From: [Travis Ritchie](#)
To: [Elizabeth.Barker](#)
Subject: RE: [EXT] Request for Approval Under Air Emissions Permit 60-010-01 Faro Rapids Generating Station
Date: January 10, 2024 8:27:35 AM
Attachments: [image006.png](#)
[image007.png](#)
[image008.png](#)
[image009.png](#)
[image010.png](#)
[image011.png](#)

From: [Travis Ritchie](#)
To: [Elizabeth.Barker](#)
Subject: RE: [EXT] RE: Faro Station Modifications
Date: February 20, 2023 9:53:31 AM
Attachments: [image002.png](#)
[image003.png](#)
[image004.png](#)
[image005.png](#)
[image006.png](#)
[image007.png](#)

RE: AIR EMISSIONS PERMIT NO. 60-010-01 FARO GENERATING STATION – PART 2, CLAUSE 5 – REQUEST FOR APPROVAL OF CAPACITY REPLACEMENT

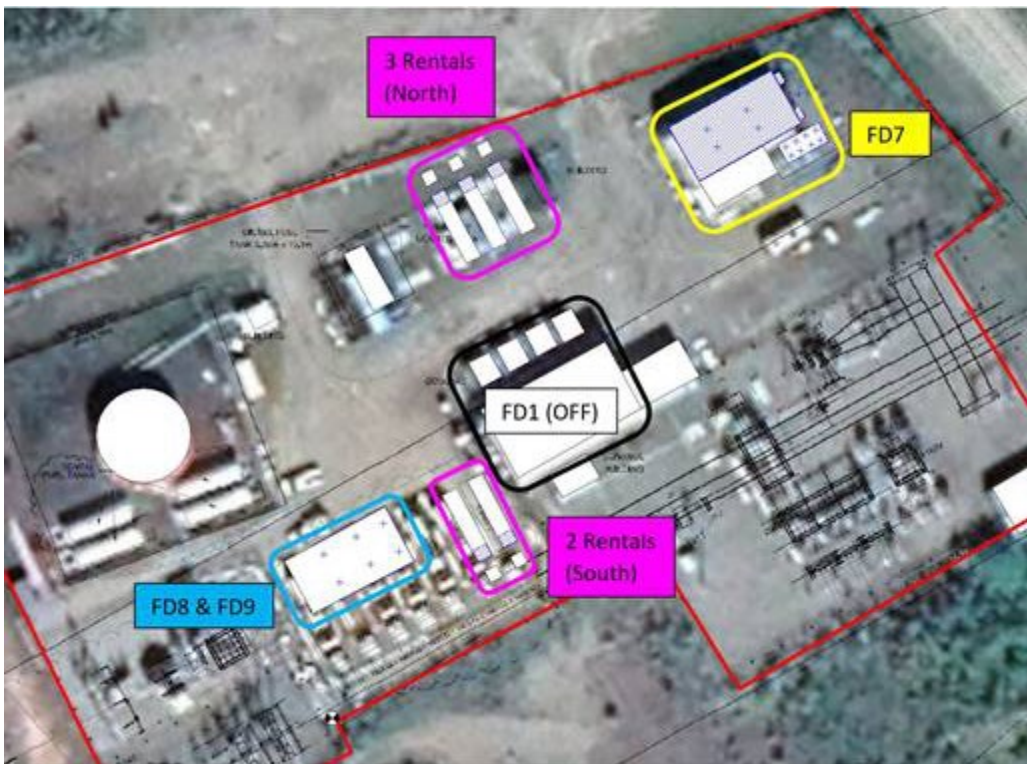
Which rental generators are being moved?

How far from their current location? A figure would be ideal. **RESPONSE: See above and attached.**

RESPONSE: Due to noise complaints we are planning to relocate 3 of the remaining 5 rental units to a location approximately 45 metres northwest of their current location. This will allow the existing FD1 building to provide some sound attenuation during their operation. We are evaluating the feasibility of additional sound attenuation for the remaining rental units as part of our planning, but don't have an engineering assessment or cost estimate completed yet. See draft site sketch below for planned locations of units.
